Project	IEEE 802.16 Broadband Wireless Access Working Group < http://ieee802.org/16 >	
Title	CBC Mode and Initial Vector for the AES algorithm	
Data Submitted	2005-01-24	
Source(s)	Sungcheol Chang Jaesun Cha Seokheon Cho Chulsik Yoon ETRI 161, Gajeong-dong, Yuseong-Gu, Daejeon, 305-350, Korea	Voice: +82-42-860-5456 Fax: +82-42-861-1966 scchang@etri.re.kr chosh@etri.re.kr jscha@etri.re.kr
Re:	This is a response to Sponsor Ballot 16e on P802.16e/D5..	
Abstract	The document contains suggestions on the changes in IEEE P802.16e-D1 that would support efficient key management method for the multicast service.	
Purpose	The document is submitted for review by 802.16 Working Group members.	
Notice	This document has been prepared to assist IEEE 802.16. It is offered as a basis for discussion and is not binding on the contributing individual(s) or organization(s). The material in this document is subject to change in form and content after further study. The contributor(s) reserve(s) the right to add, amend or withdraw material contained herein.

CBC Mode and Initial Vector for the AES algorithm

Figure xxx – CBC IV generation.

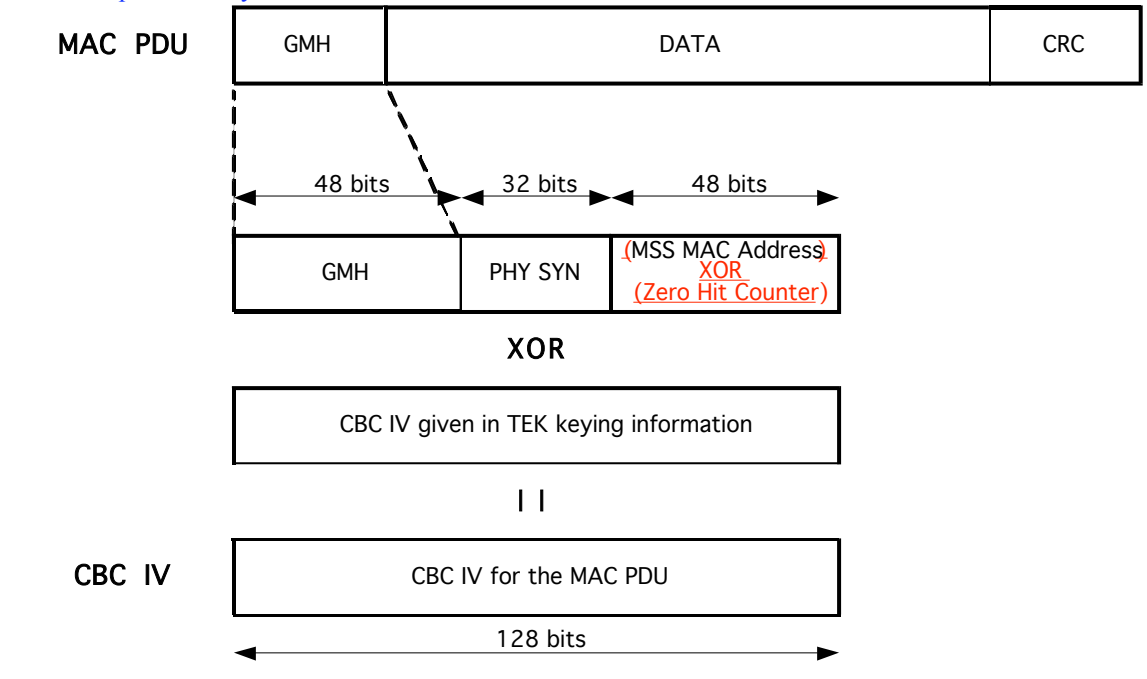
[Add section 7.8.2.3 in page 149 as follows]

7.8.2.3 Data encryption with AES in CBC mode

7.8.2.3.1 CBC IV generation

The Zero Hit Counter is initialized into zero when the Key Reply message is received, and updates whenever either the PHY Frame number is zero or MAC PDU is received in a frame. The Zero Hit Counter increases by one if the previous PHY Frame number is equal to or greater than the current PHY Frame number.

The CBC IV shall be calculated with the exclusive-or (XOR) of (1) the IV parameter included in the TEK keying information, and (2) the 128-bits content which is a concatenation of the 48-bit MAC PDU Header, the 32-bit PHY Synchronization value of the MAP that a data transmission occurs, and the XOR value of the 48-bit MSS MAC address and the Zero Hit Counter.

The CBC IV shall be updated every MAC PDUs.

If the MAC PDU is decoded from several channel coded blocks transmitted at different frames in HARQ operation, the MAC PDU payload must be decrypted with the CBC IV value which are generated from the PHY Synchronization value of the MAP when spid=0.
